June 10, 2019

**RE: Response to Planning Division Staff Report
760-780 Regent Street**

EXHIBIT A

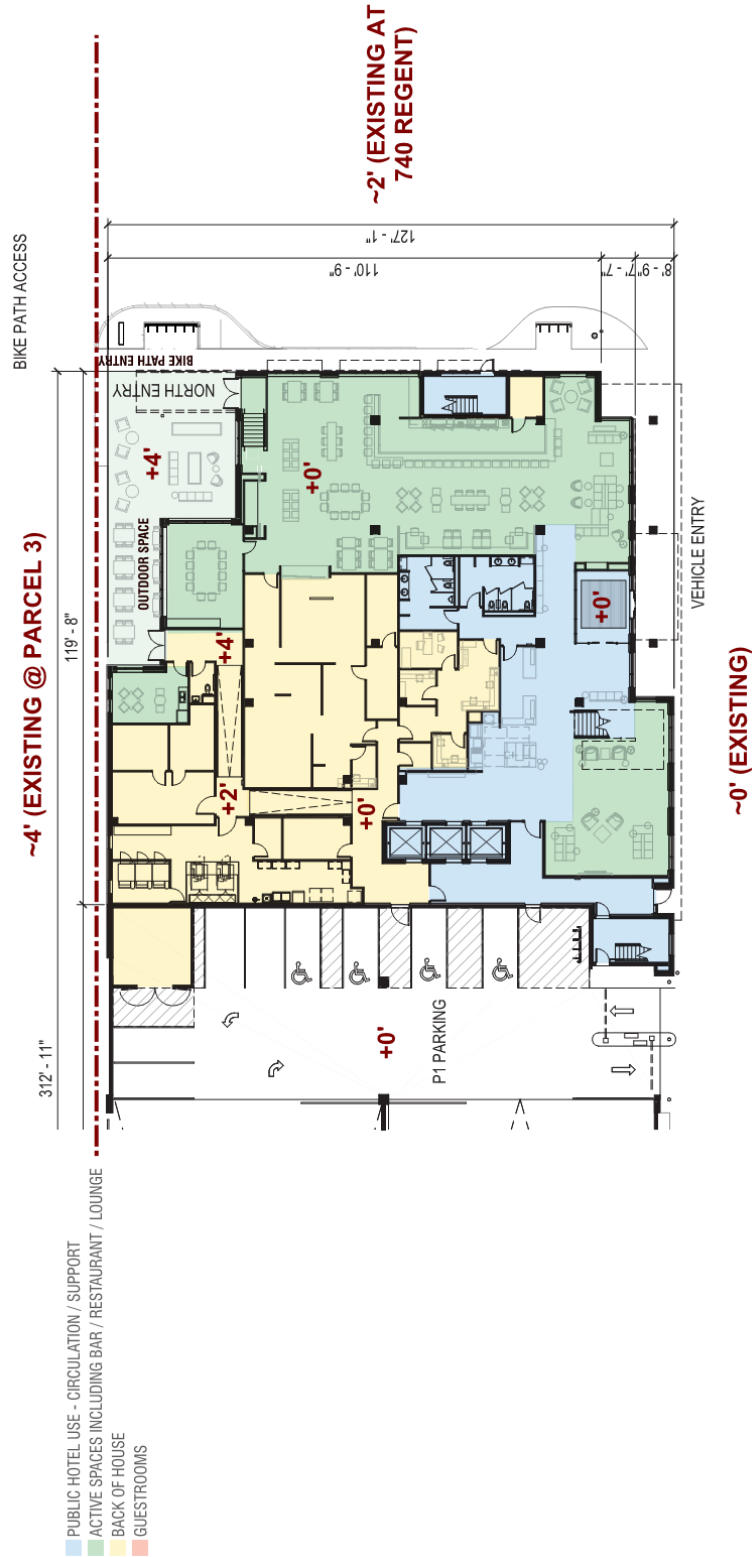
In response to staff conditions, we have raised the elevation of the northern building edge to eliminate our retaining wall requirement within the City leased area (see Exhibit A). We have limited the construction work required within the City leased area to minor grading and drainage, public utilities (sewer, sanitary, water, electric and gas), landscaping, sidewalk connections, construction staging and restoration of the surface parking lot area. Our team has discussed this scope of work with Mr. Doran Viste, City Attorney, who was amenable to this scope of work being done under the existing lease and was intending to relay this approach to Engineering staff and Traffic Engineering staff. The parking within the City leased area would no longer connect through the hotel parking structure, would be re-stripped (see Exhibit B for re-stripping options), and the intent is to use this parking for hotel employees only.

In order for the Applicant to execute this revised strategy, staff conditions #10, #29, #30, #32 and #39 must be revised to allow for minor grading and drainage, public utilities (sewer, sanitary, water, electric and gas), landscaping, sidewalk connections, construction staging and restoration/re-stripping of the surface parking lot area to be permitted in the City leased area
